RECORD COPY of ASI-018, included as  
3 of 6 ASIs for reference with SPA-03

PROJECT NAME:	One River Run (Kindred) 75 Hunki Dori Ct. Keystone, CO 80435	ASI #:	018	<input checked="" type="checkbox"/> OWNER <input checked="" type="checkbox"/> ARCHITECT <input type="checkbox"/> CONSULTANT <input checked="" type="checkbox"/> CONTRACTOR <input type="checkbox"/> FIELD
PROJECT #:	117033	DATE OF ISSUANCE:	04/15/2024	
OWNER:	One River Run Acquisition Keystone Investments, LLC 132 West Main Street, Suite D Aspen, CO 81611	ARCHITECT:	OZ Architecture, Inc.	
		TO CONTRACTOR:	PCL Construction Services, Inc	
		CONTRACT FOR:	GMP/Building Permit Resubmittal	
		CONTRACT DATED:	September 23, 2021

DESCRIPTION: This ASI provides updated Architectural drawings to remove the Plaza Lift (Keynote 14.01) in the vicinity of the monumental stair on the South side of Area D and to change access and control as required to provide an alternate Accessible Route between the Gondola Plaza on L0 and the Public Courtyard on L1 through the Hotel portion of the project. These changes are being made at the request and direction of the Owner. Architect has confirmed with the AHJ that removing the lift is allowable by Co

ISSUED FOR:  
 GMP / BUILDING PERMIT RESUBMITTAL  
 SHEET TITLE:  
 GARAGE FLOOR PLAN - OVERALL  
 SCALE:  
 As Indicated  
 SHEET NUMBER  
**A-100**

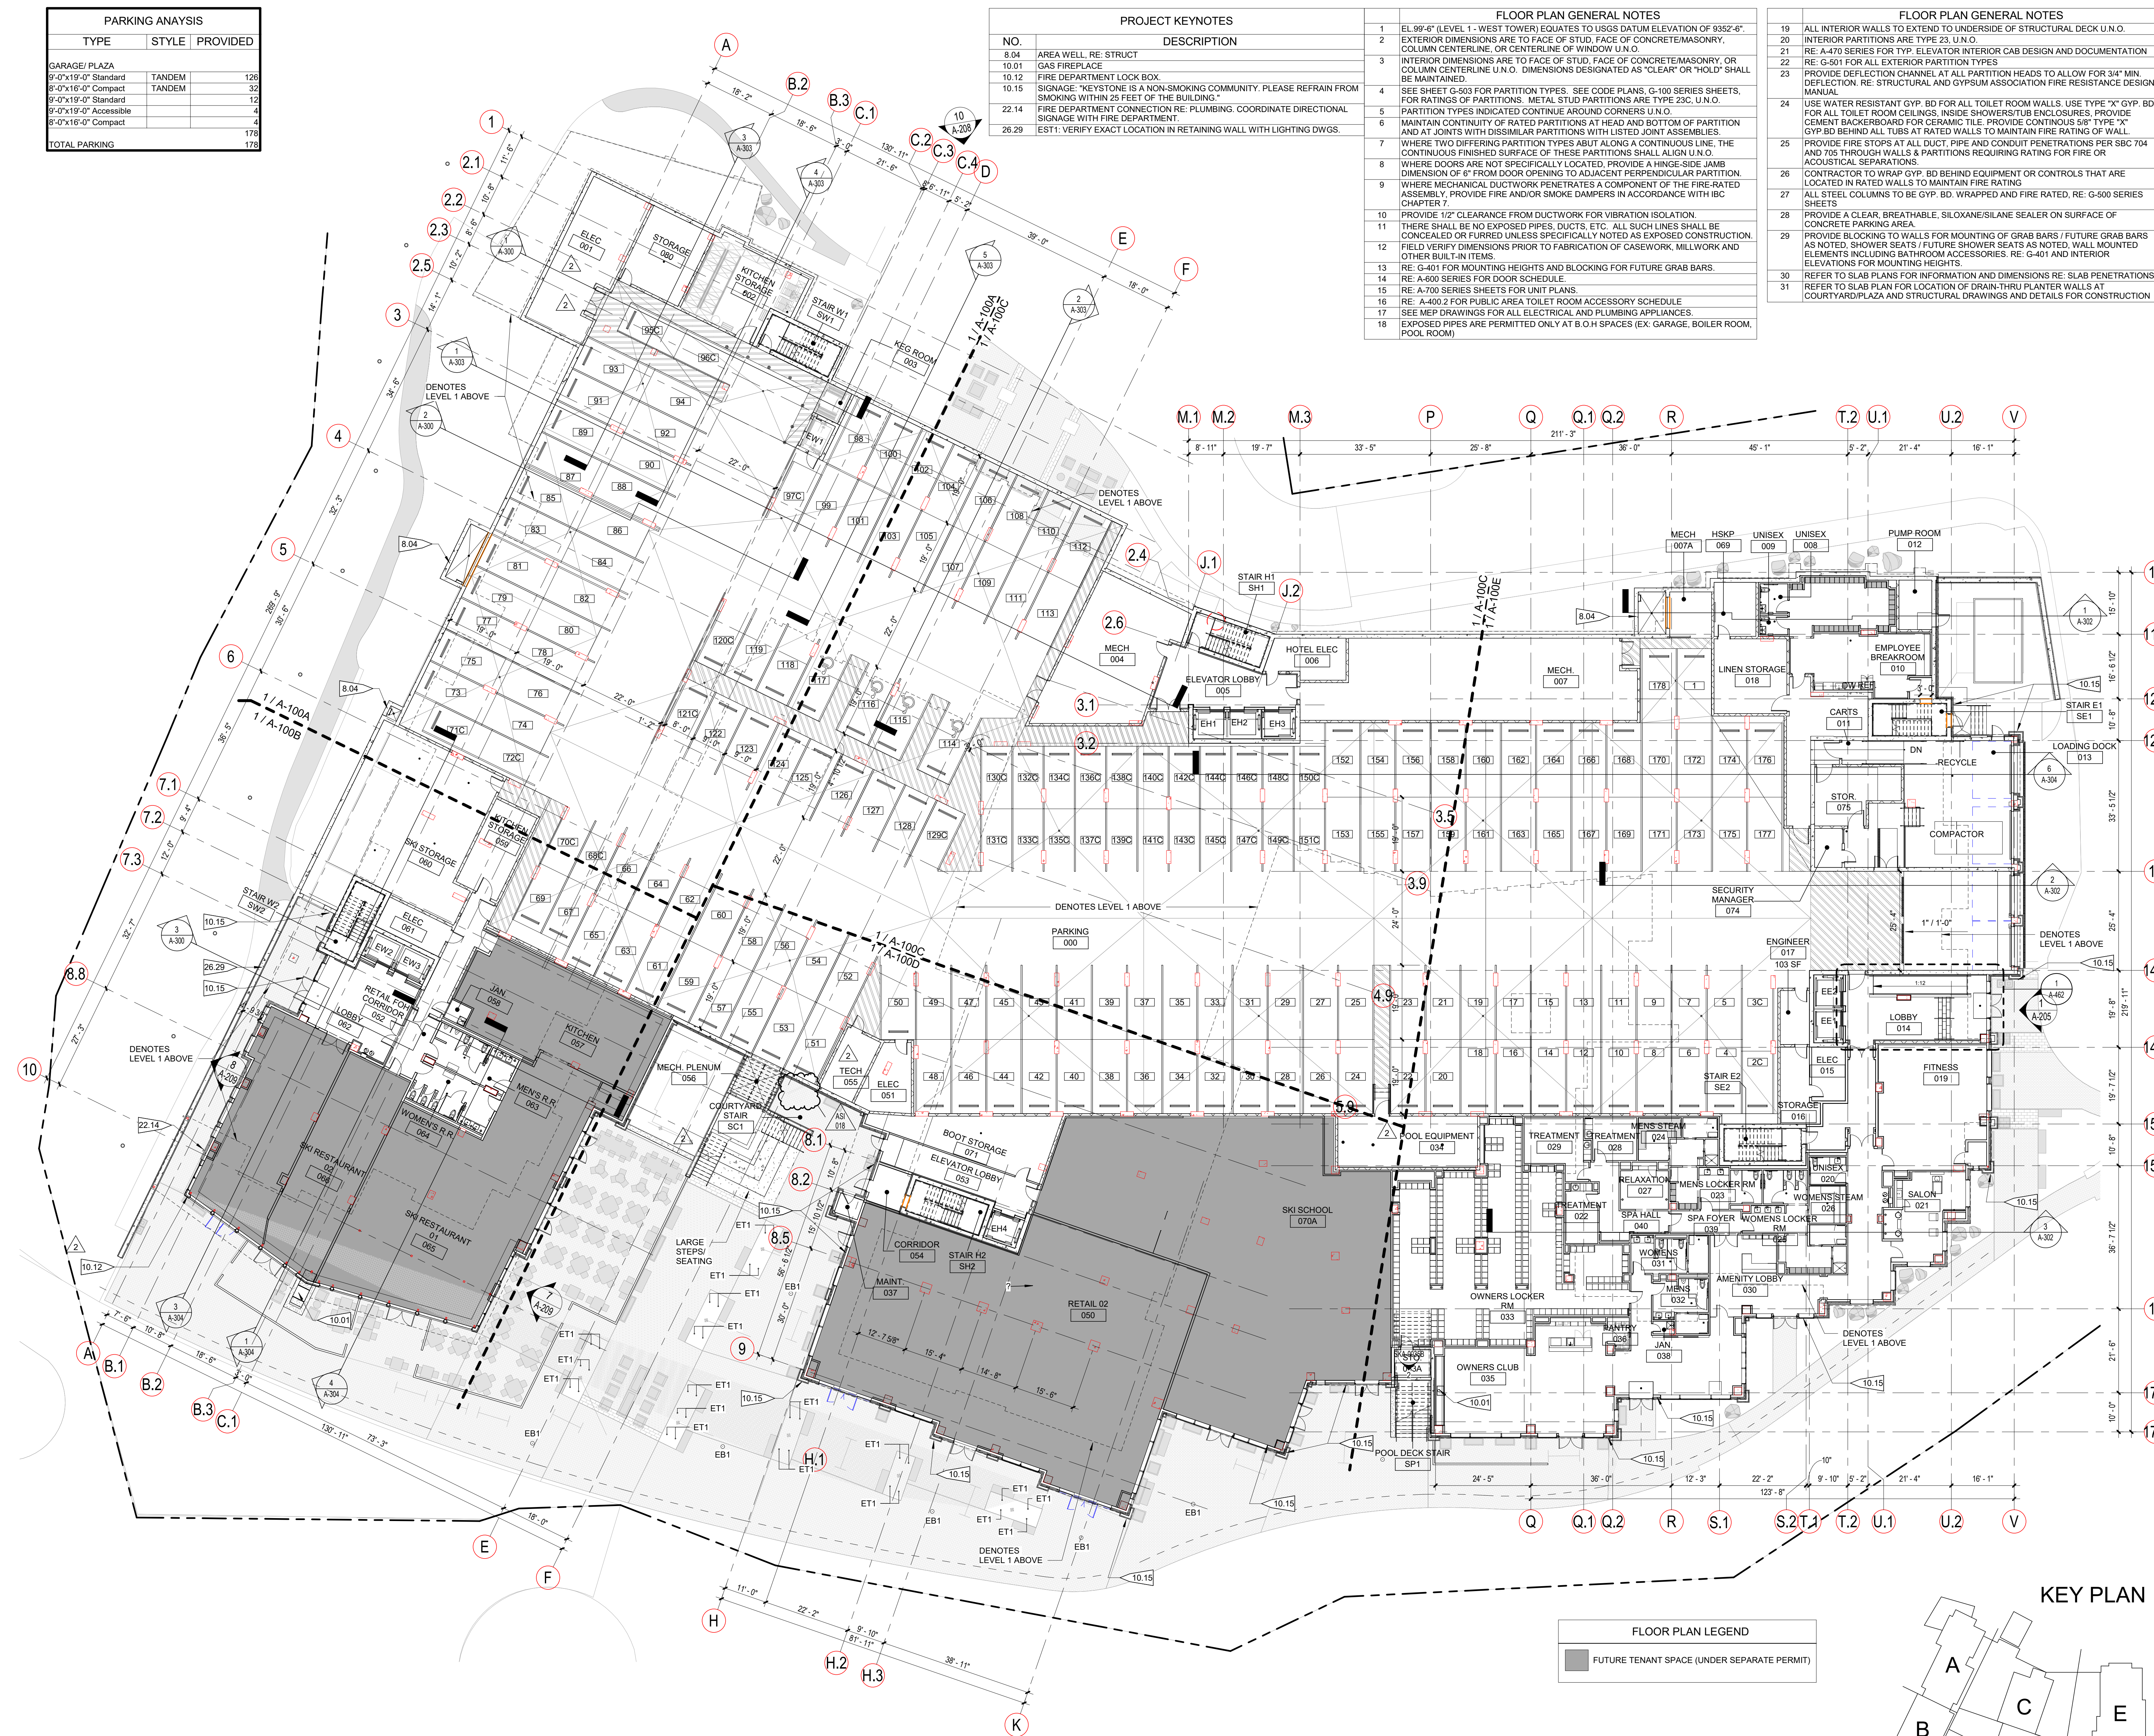
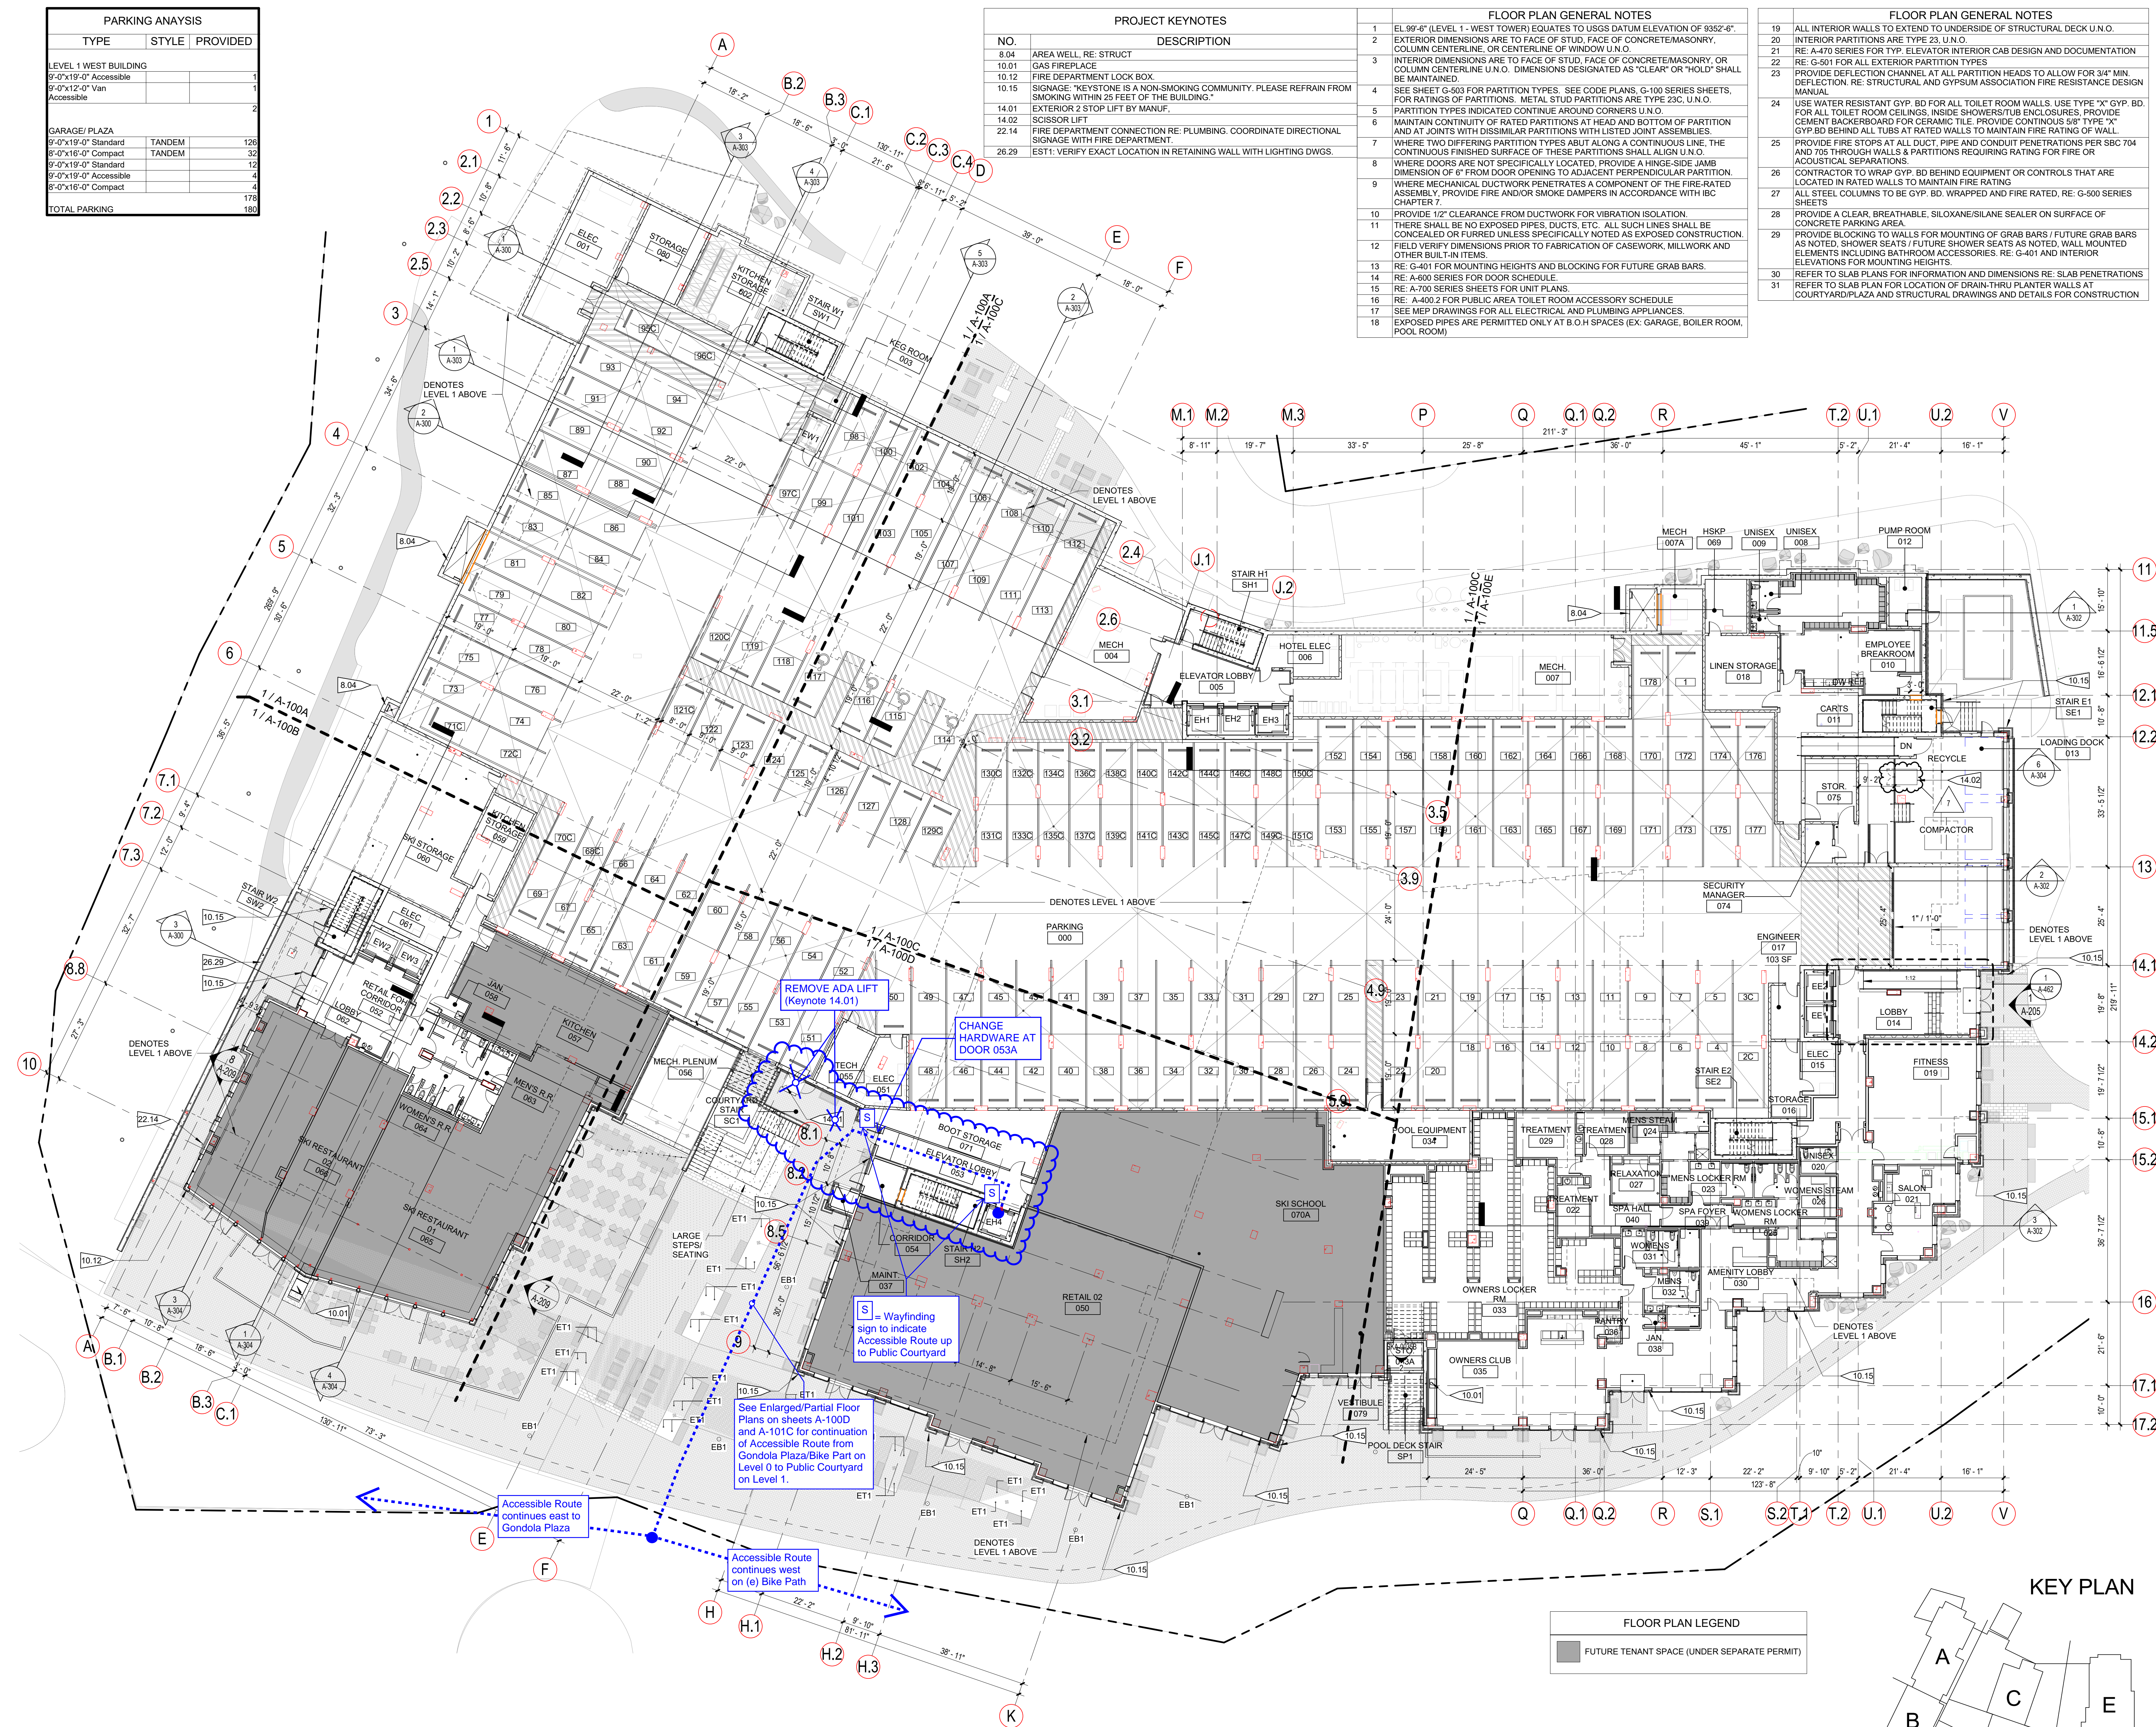
- 1.1 Remove ADA Lift (Keynote 14.01) and associated structural infrastructure. Maintain J-BOX & receptacle as shown on elec. drawing.
- 1.2 Change hardware on Door 053A & 054 so that this exterior door remains unlocked (no card reader) at all times.
- 1.3 Add Accessible Route signage on exterior wall adjacent to Door 053A.
- 1.4 Add Accessible Route signage on interior wall adjacent to Elevator EH4.
- 1.5 Change Elevator control at EH4 so that this elevator is available for public use from L0 to L1 (only) at all times; card reader may remain to control access to L2 and above.
